37/03-04UU 7220 Spruce Ave
Takoma Park Historic District

7220 Spruce - before and after (second story addition to Contributing Resource)

HISTORIC PRESERVATION COMMISSION STAFF REPORT

PROPOSAL: Construction of 2nd-story addition

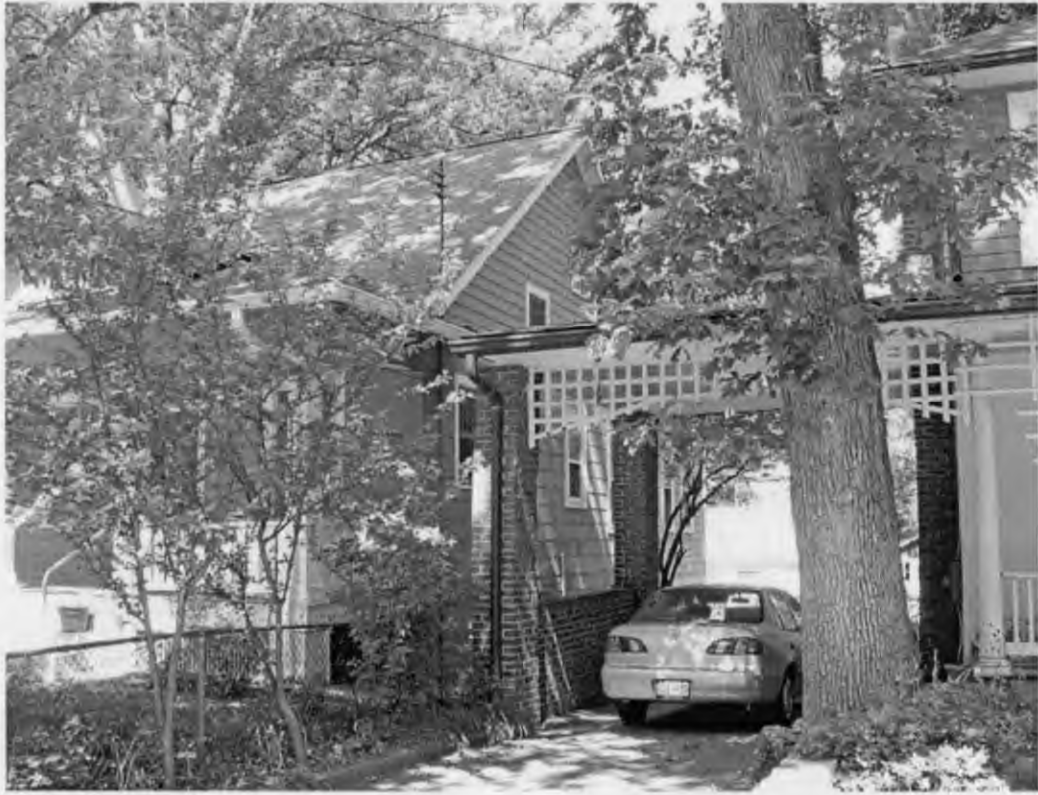
I have a question that relates to the pictures I'm attaching here concerning 7220 Spruce Ave. The contractor is in the process of demolition and discovered that the existing chimney does not meet code, so extending it up as is is (probably) not an option. He is going to clarify with a code official tomorrow just how much will need to be done to satisfy the county.

Depending what the county says, the chimney may have to be demolished down to where the corbels start extending out wider towards the bottom (see photos). The code problem is that there is only about 6-inches of masonry surrounding the flues (code requires 8-inches), so we may have to add 4-inches of brick on three sides; the side facing the sideyard will have no framing against it so the requirement doesn't (luckily) apply there. HOWEVER, adding brick to the sides is a bit tricky. Building a separate 4-inch layer on the outside of the chimney is not the most stable way of adding masonry mass. The new masonry wants to pull away from the existing masonry. Masonry ties can be used and toothing in brick can be done but the existing masonry is not in great shape to do either. One possible option would be to demolish the existing chimney, like I said before, down to the corbels, and build up a new thicker masonry chimney up to the required height, then stucco it. That is also the most expensive option.

Option two would be demolish it down to the corbels, but build a new wood frame chimney with metal flues inside, and then add Dryvit (exterior insulation board) with a stucco finish on it. It will look like stucco, and save a lot of money.

exactly as is
rebuild in real brick
if painted → paint
if stucco coating → okay

DESIGN C

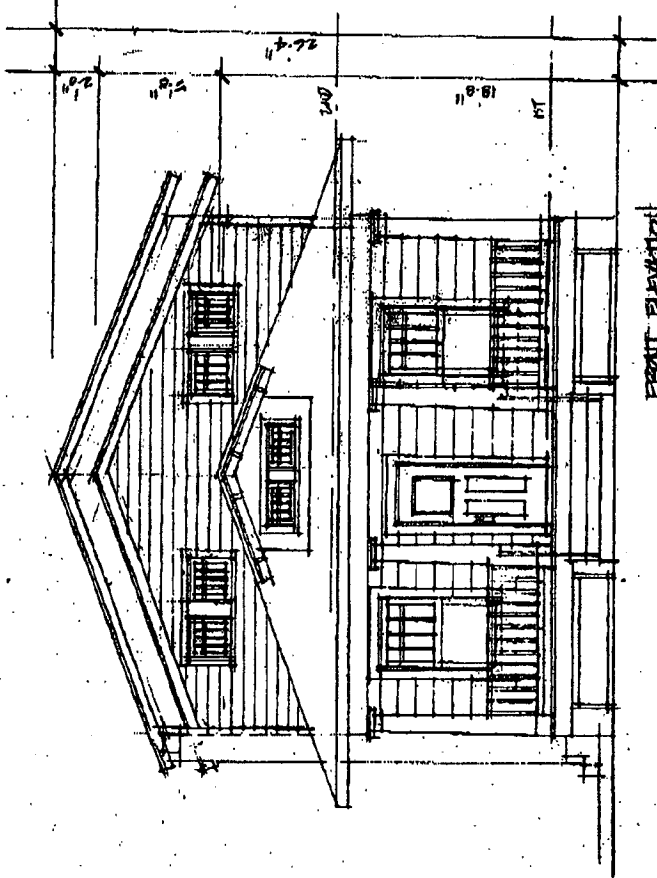
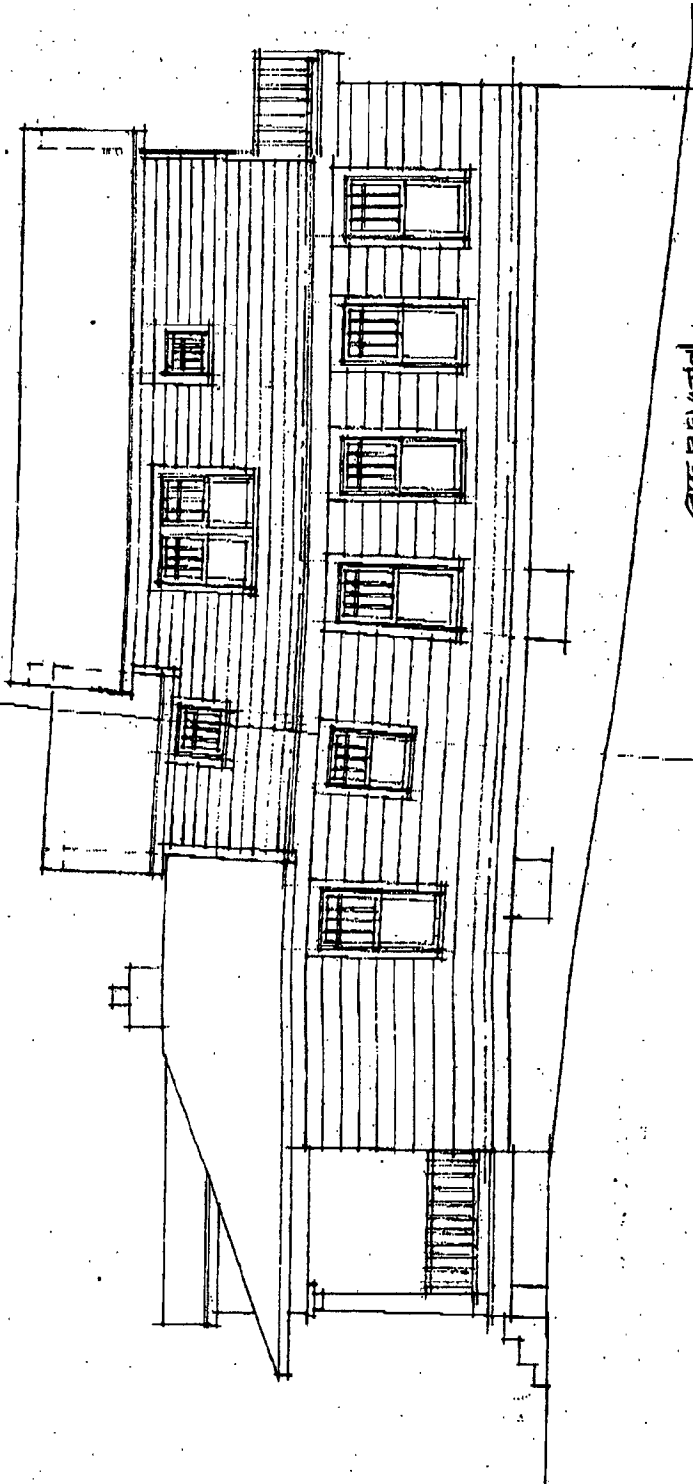
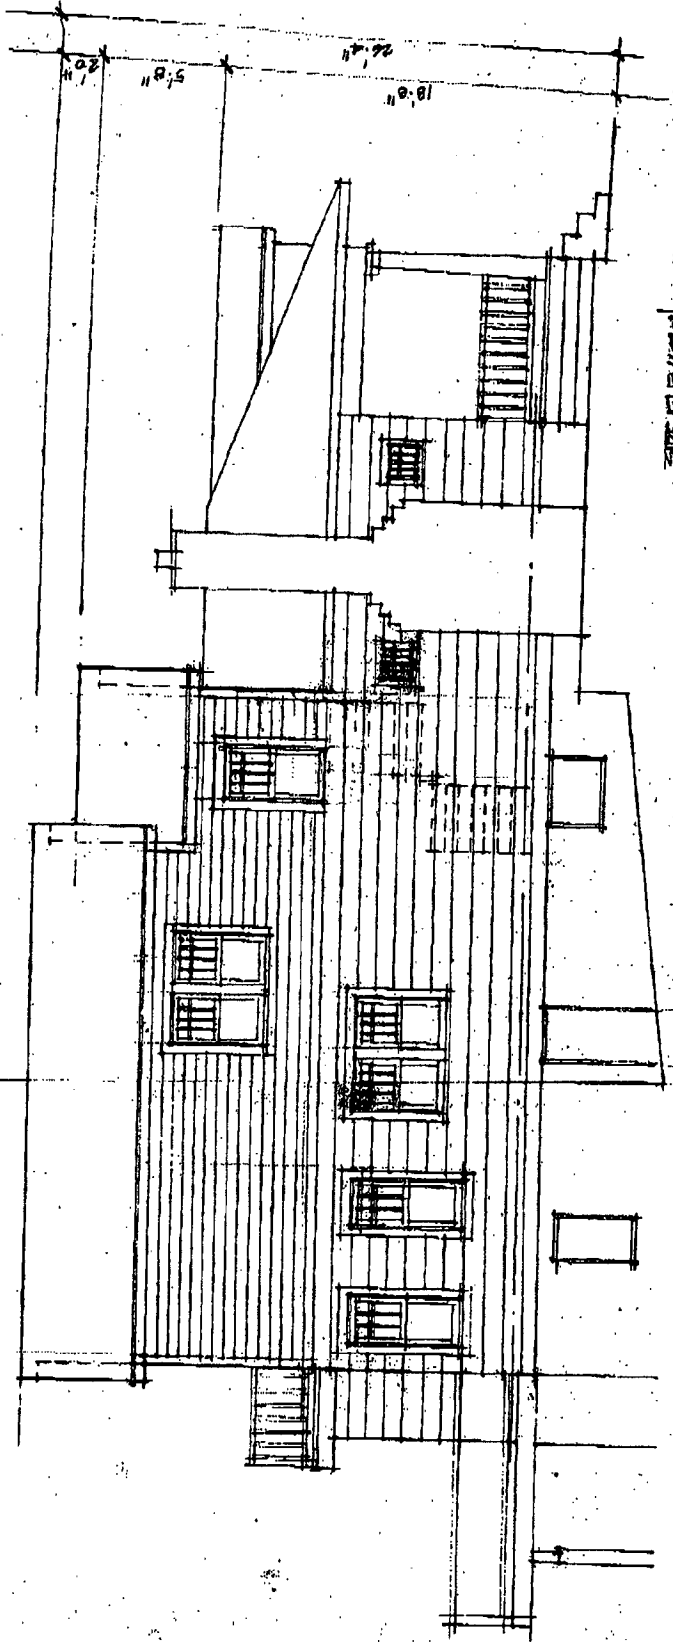
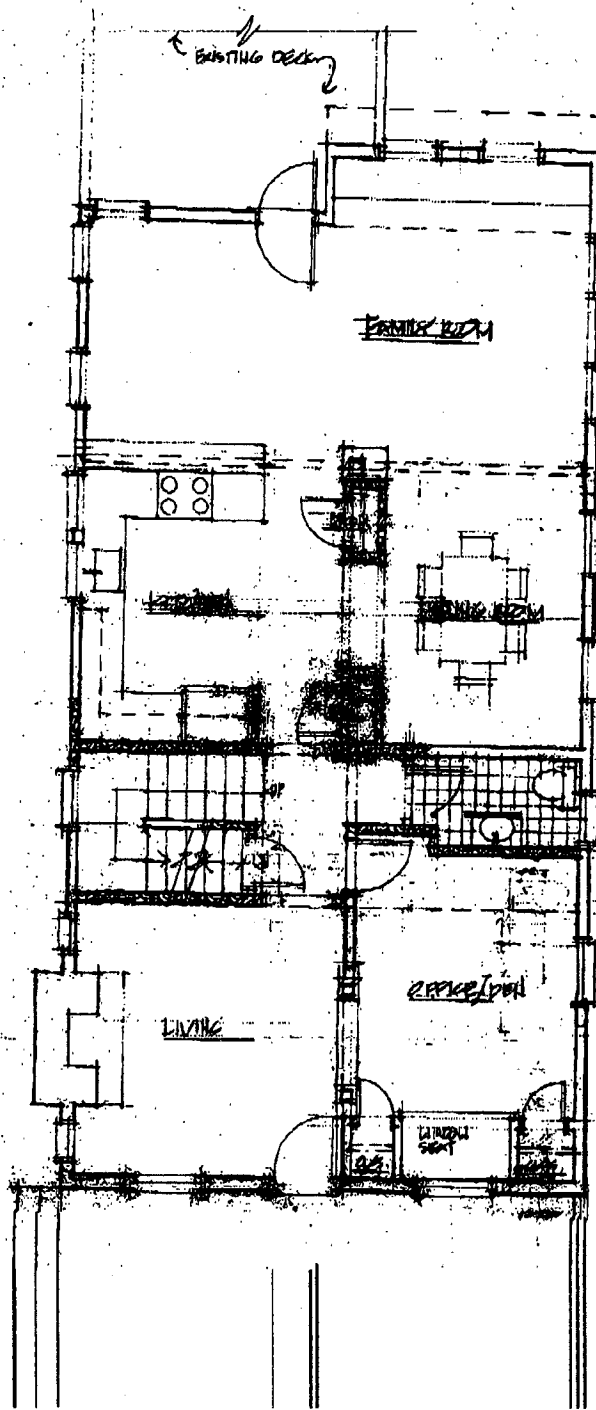
24 MS. O'MALLEY: Yes, circle 6, you know, on plan C
25 you had it quite a ways back.

16 MS. ALDERSON: And you could add more windows than
17 you have in design C, if you need to get more daylight.

8 MS. WILLIAMS: To just back up a little bit. I am
9 not quite sure why people of Historic Takoma, why staff, why
10 the general, you know, response has been more favorable to D
11 over C. I guess, I sort of see as being more in the right
12 direction, and I'm not quite, I feel like I am missing
13 something.
